**Subject: Comment and objection for Planning Application 13 Chalcot Gardens:  
(2024/4823/P)**

**Objection to 13 Chalcot Gardens: (2024/4823/P) Proposed replacement Outbuilding (Garden Studio) within the rear garden.**

Figure 1. Garden Studio Proposal and scale as shown in application. (Ref pg. 11)

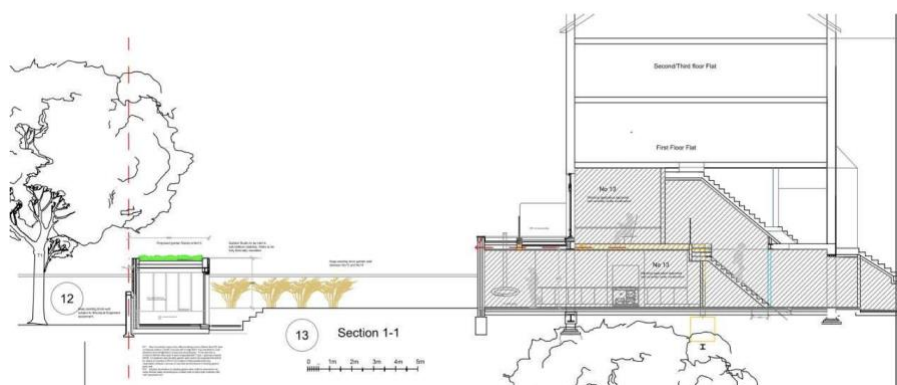
The Garden Studio is set 10m from the main residences and facing the residences and as outlined in Policy A1 Section 2.4 this condition is not met. Further to this the nature of the low boundary walls, which is in the character of the Conservation Area and Gardens, will mean inevitable overlook. Please see Figure 1 below for reference of distances as per application.

*Figure 3. Overlook of garden building and agreed roof terrace on neighbouring residences*

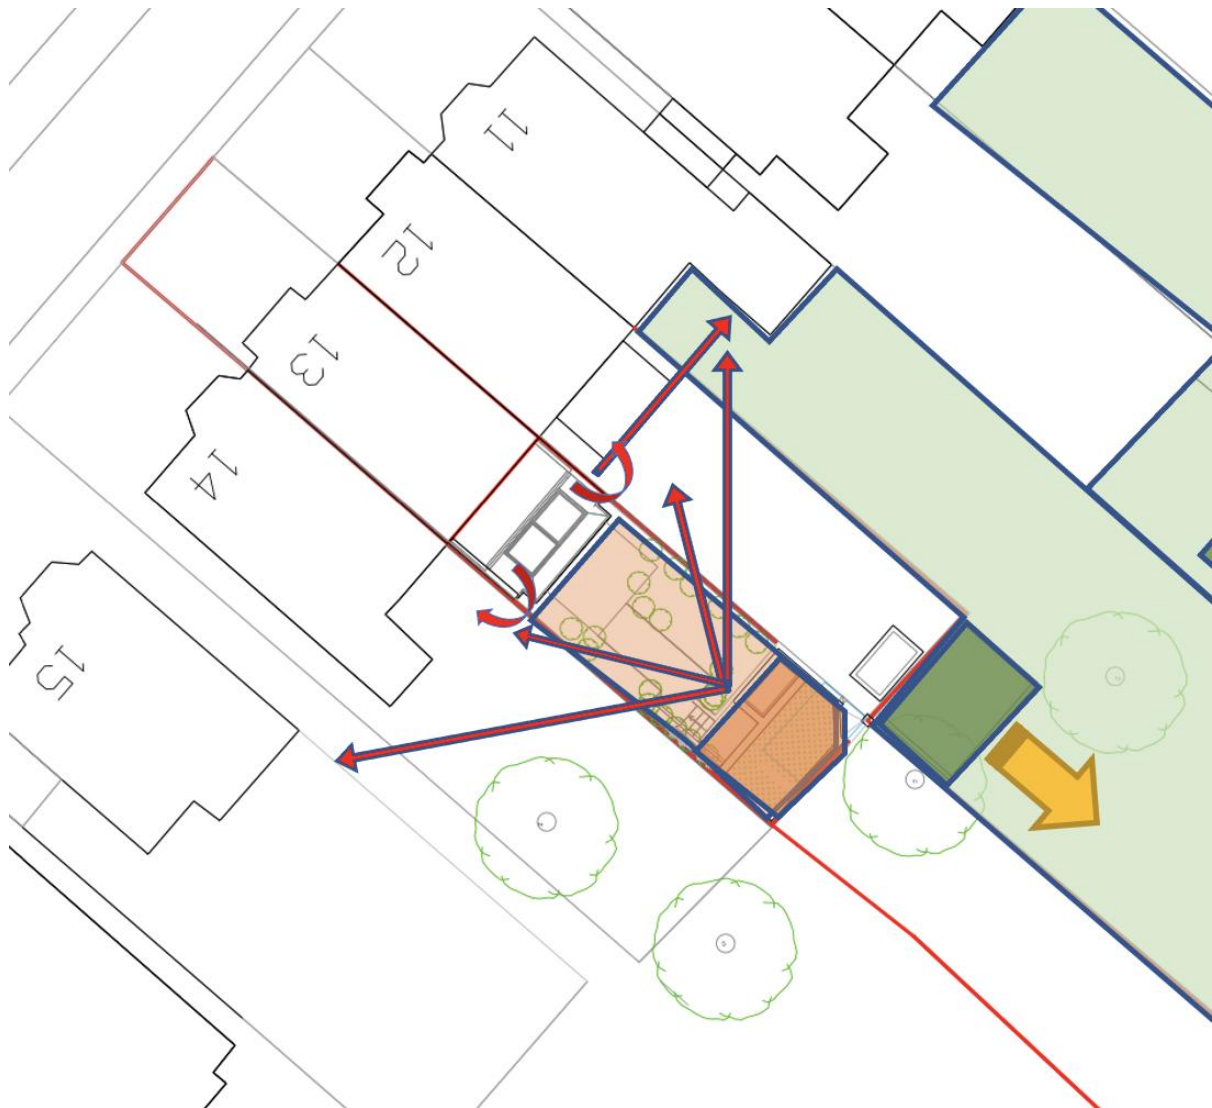
The approval of a Garden Studio in conjunction with planning for an extension already provide outlook in all directions including from the sides and directly onto resident rooms. See Figure 3 below and Images 1 to 4.

The previous outlook covered a 180-degree angle impacting privacy from the sides of residents, however with a further outlook now facing the building the cumulative outlook of both proposals in combination gives a 360-degree outlook. When the plans for the Garden Studio are added to this, neighbouring properties would now have to be blinkered by 1.7m high screening. Following the same logic, will have to have screening continuing for a further 10m to mitigate the impact on privacy. Even if it was feasible to add screening to a height of 1.7m across both boundary walls, it would still be unlikely to preserve the privacy of the remaining 4 floors in each of the affected 4 residences (16 floors and 4 balconies No. 10, No. 11, No. 13, No. 14). The remaining outlook of the proposed Garden Studio would still be the upper residential windows even if a screen was added.

*Figure 5. A large portion of the boundary wall is raised.*

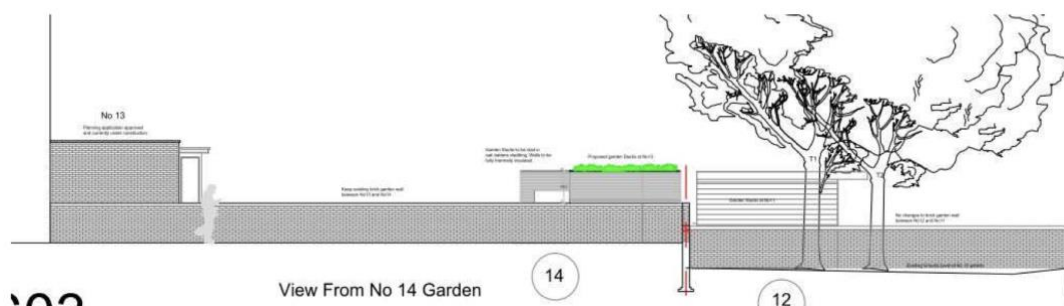
Further to the erosion of the garden space the erection of high walls on either side take away from the character of the conservation area defined by low boundary walls which allow for a sense of openness and the free movement of local wildlife (see Figure 5). The Garden Studio proposal is also wall to wall and effectively hermetically seals the Garden in no. 13 from the other gardens impacting the nature of the conservation area and the movement of wildlife (see Figure 6). The above statement is echoed in the Official Planning Guidance on Design : Paragraph 4.41 of which the sections states:

*Figure 6. Wall to wall extensions seal off the garden from other and raise boundary walls.*

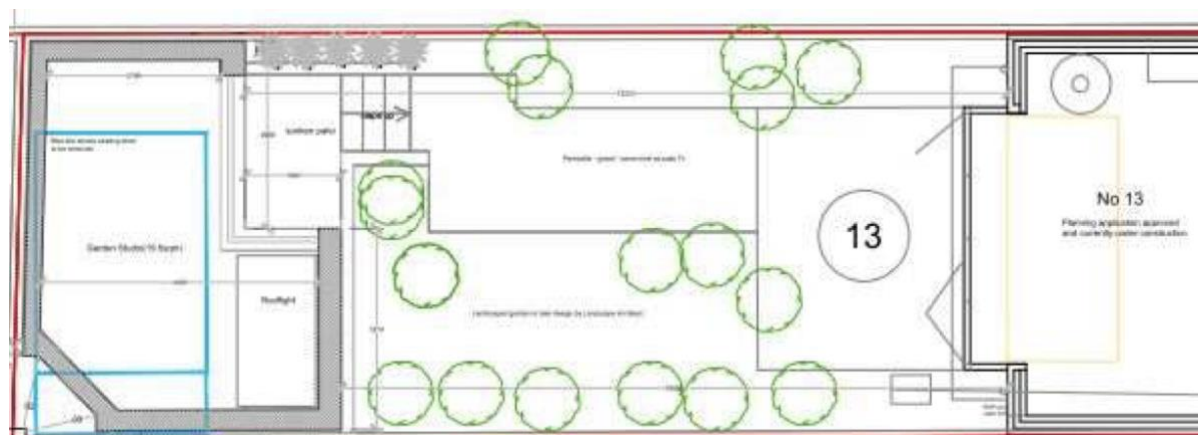
As noted in Figure 6 the Garden Studio proposes to build walls end to end hermetically sealing off No 13 between the 4m extension and the Garden Studio. This will stop the natural movement of wildlife and create a dead zone of concrete, glass and light.
